DUKE POWER COMPANY

Re: McGuire Nuclear Station
Docket Nos. 50-369 and 50-370

SAFETY EVALUATION OF UHI HOLDDOWN ASSEMBLY SPRINGS

FIG 1 - Old UHI HOLDDOWN ASSEMBLY

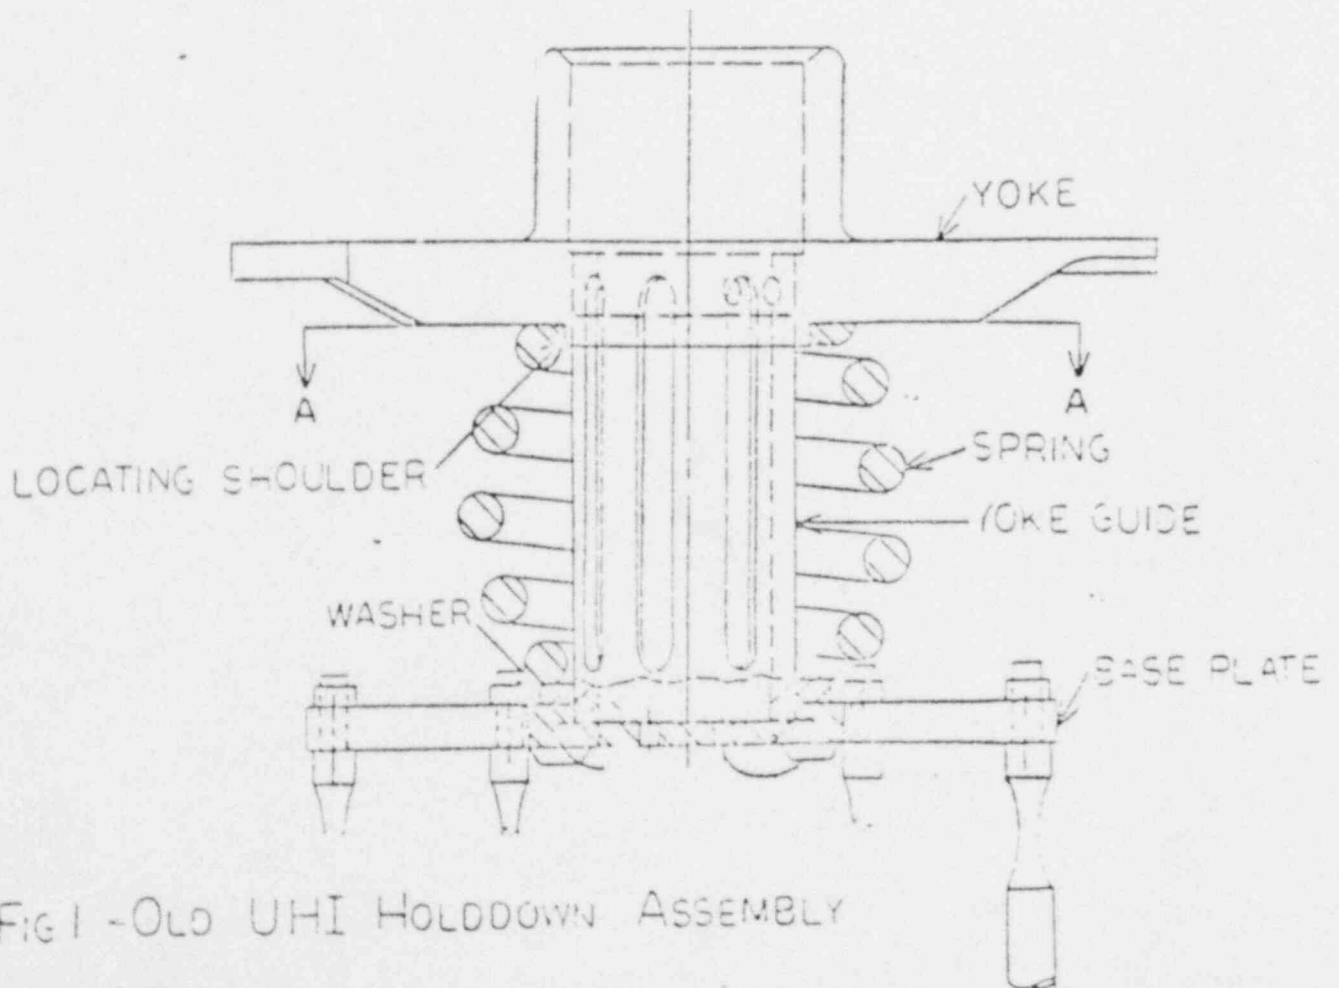
A. OLD HOLDDOWN SPRING

Westinghouse has examined the consequences of operation with broken springs and has concluded that operation with springs of the old design (See Figure 1) in non-fuel bearing components for one cycle and application of the new spring design for other components do not constitute a safety concern. The evaluation considers a most limiting practical case of spring breaks of the type generally observed in the examination of spring breaks in the foreign UHI reactor or all springs broken near the center with the two parts intertwining with each other.

There is no visual evidence of any loose parts. Breaks as reported from examination of an affected foreign UHI reactor (plant A) were clean with no evidence of fragmentation. The spring design is such that the end coils are inactive and the close tolerances with the hub of the holddown assembly ensures the spring ends on either side of the observed breaks are fully captured.

FIG 2-NEW UHI HOLDDOWN ASSEMBLY

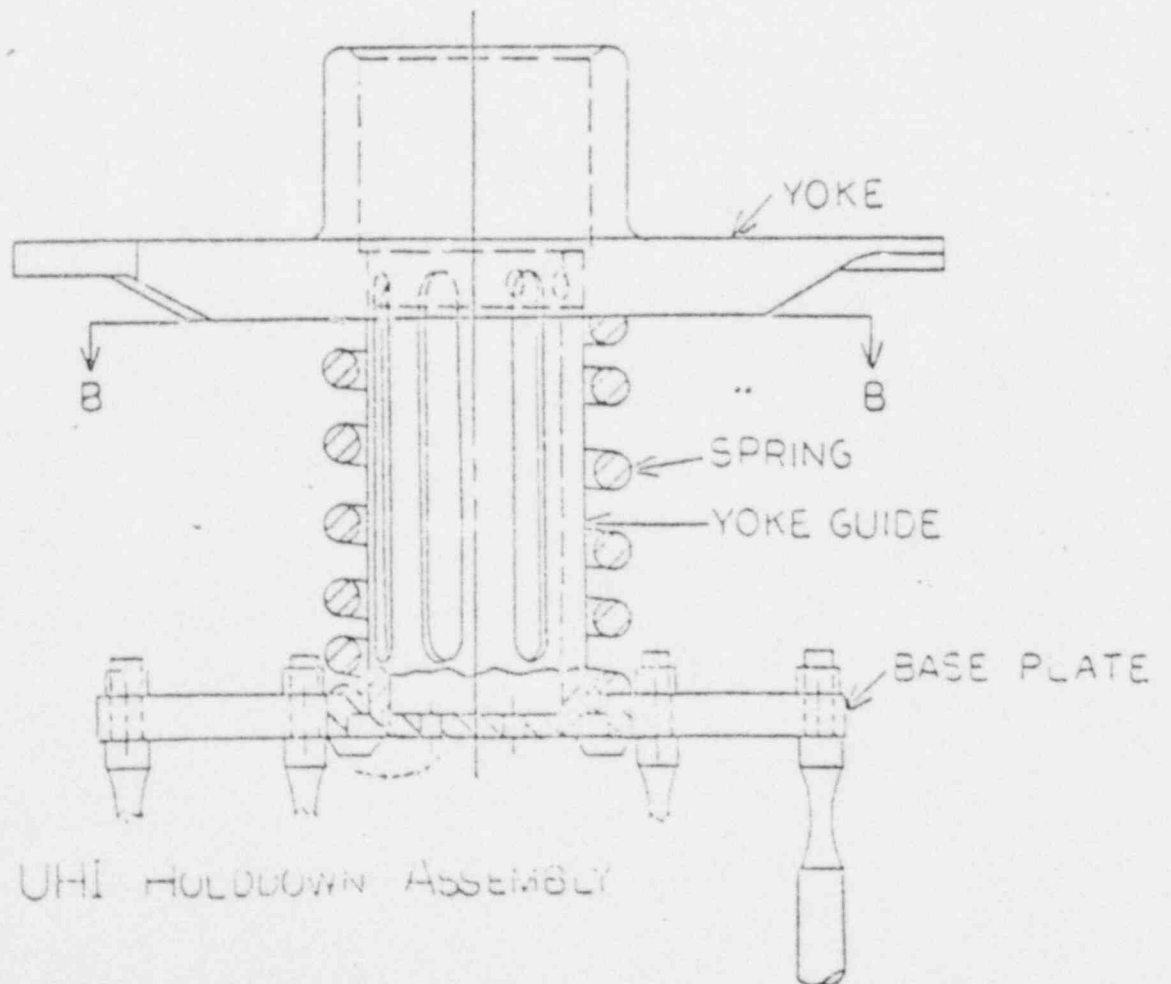
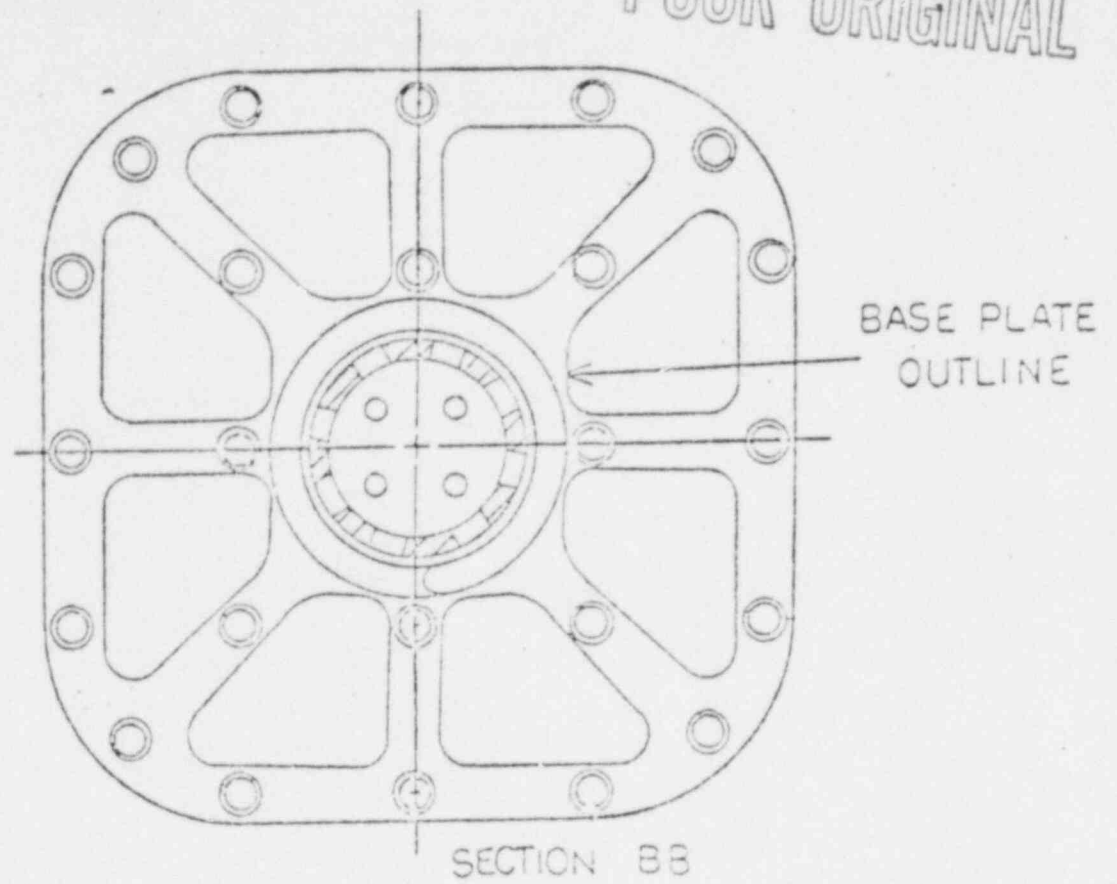
E. NEW HOLDDOWN SPRING

Westinghouse undertook a design and testing effort to revise the UHI holddown spring design in order to preclude failures such as those identified. This new design is shown in Figure 2 and incorporates the following features. Mean stress levels have been reduced and material grain size has been defined for better fatigue properties. Compared to the old design, the spring wire diameter was decreased from 0.33 to 0.270 inches and the free length decreased from 4.51 to 3.97 inches. These changes provide reduced stresses while maintaining adequate holddown force. The straight helical design with evenly spaced coils reduces the sensitivity of the spring to vortex shedding. Care was taken to ensure that the new spring fundamental frequency was not within the range of the reactor coolant pump pulsing frequency, so that the effect of this source of excitation is reduced. Inconel 718 was selected as the material, as with the original spring, since it combines high strength, corrosion resistance and fatigue life with low irradiation relaxation.

The spring design continues to retain the close fit with the hub of the holddown device so that even in the unlikely case the spring should break, the ends would be retained and the safety considerations discussed for the old design would continue to apply.

Flow delivery tests for UHI support columns were performed by Westinghouse to confirm the adequacy of the new design. Flow rate variations between a UHI column with a holddown assembly and one with no assembly resulted in variations of approximately 1 percent. Cases evaluated bracketed the flow rates which would occur with the new spring design and showed that the effect of the new springs are negligible.

Flow distribution tests were also performed. Although there was some variation in distribution, the minimum flow per unit flow channel in UHI delivery range exceeded the minimum required by a substantial amount.

Westinghouse tests have confirmed that the relationship between UHI plant hardware and the heat transfer used to develop the UHI model is still valid. The present UHI model was therefore determined to be applicable, and the use of the new spring results in no change in the PCT.
